POLICE TECHNICAL ASSISTANCE REPORT

SUBJECT Survey of the Development and Evaluation of Firearms Training (DEFT) Program

REPORT NUMBER 75-064-012

FOR Los Angeles, California, Police Department

FIGURE 1
DEFT PROGRAM PHYSICAL LAYOUT

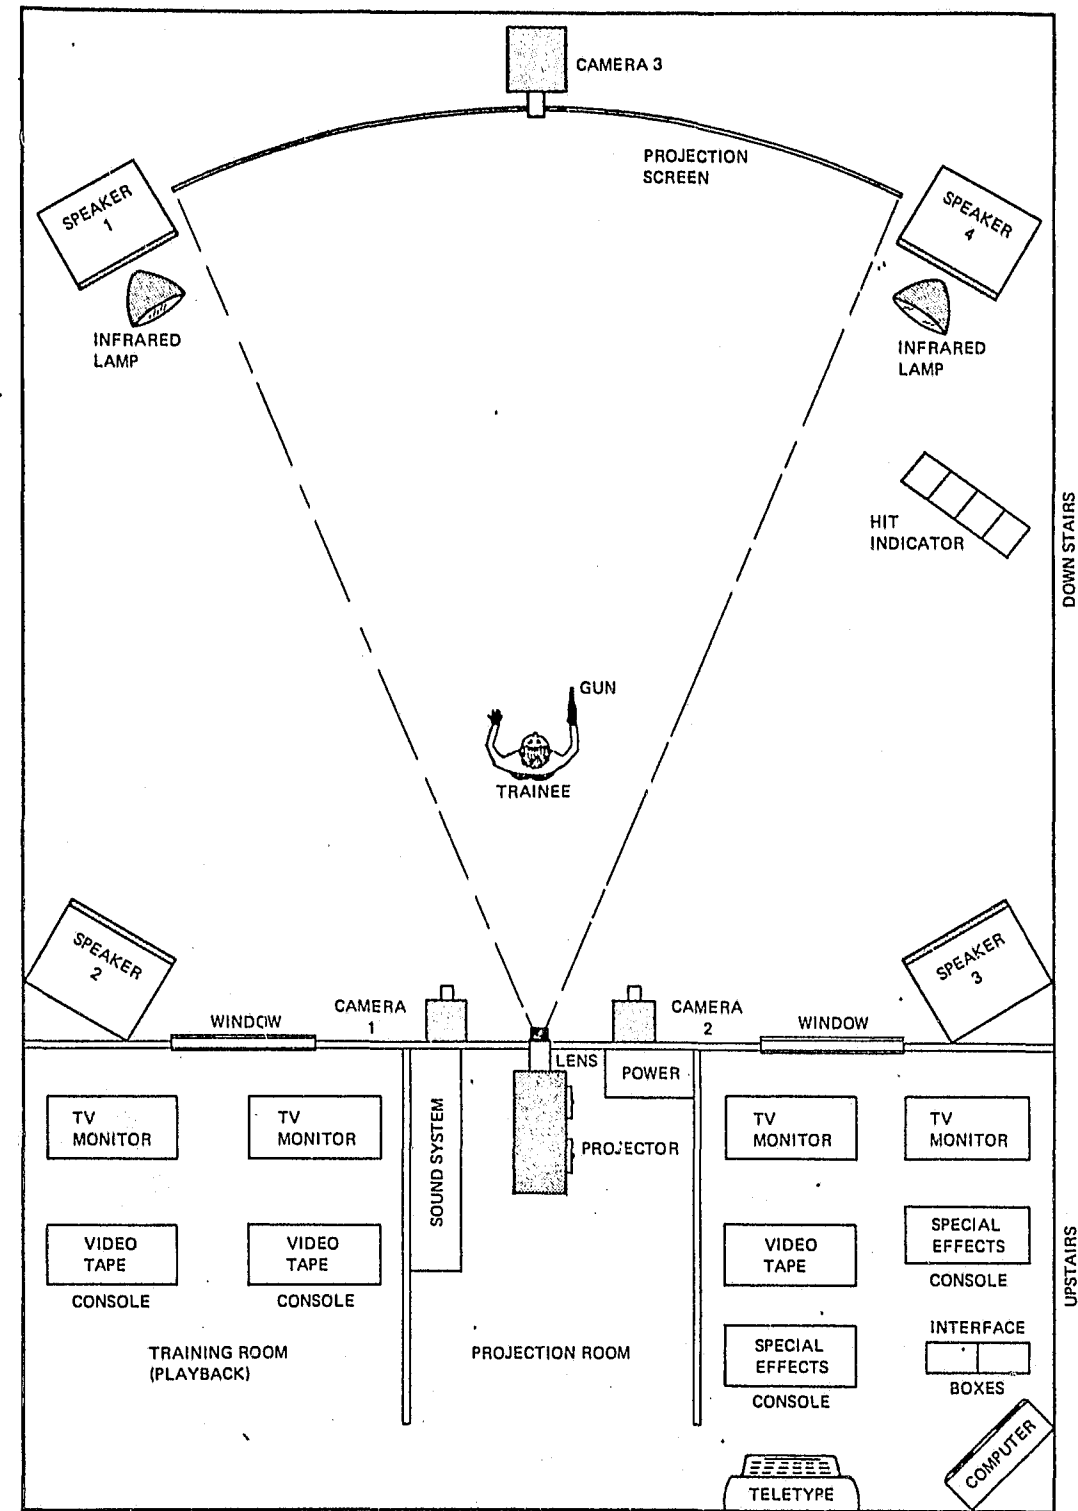
c. Video Cameras - The system contains three video cameras. Two of them (Cameras 1 and 2 in Figure 1) are standard vidicon tube cameras (Panasonic) with fixed focus 16mm F1.6 lenses. These cameras are fixed on rigid mounts connected to the upper wall surface adjacent to the projection room. The third camera is a silicon target vidicon camera and lens with an automatic iris. This camera is poorly mounted on a wooden platform with temporary metal C clamps on top of the projection screen. This mount is inadequate.

All three cameras perform poorly. The two vidicons adjacent to the projector (Cameras 1 and 2) utilize a standard vidicon tube which "burns in" an image of the screen. They also take a long time to recover from high light levels. In addition they are not sensitive enough to provide an adequate image at low light levels.

ignited incendiary fragments. Additionally, these fragments cause blooming and an excessively large impact image on the impact scoring camera (Camera 2 in Figure 1) with the result that the automatic scoring accuracy by the computer is open to question.

The existing silicon target vidicon is inadequate to monitor the trainee during low-light-level conditions. Also, the focal length of the present vidicon is not adequate to monitor facial features of the trainee during the enactment. A new low-light-level camera and lens should be selected to overcome these problems. Also, because LAPD intends to eventually employ scenarios with two trainees, a second camera mounted over the screen and pointed toward the trainees will probably be required. Additionally, in order to monitor facial features, it may be necessary to have the trainee-monitor camera joystick controlled, because it will be necessary to employ a longer focal length lens to see these features; which in turn would reduce the field of view of the cameras.
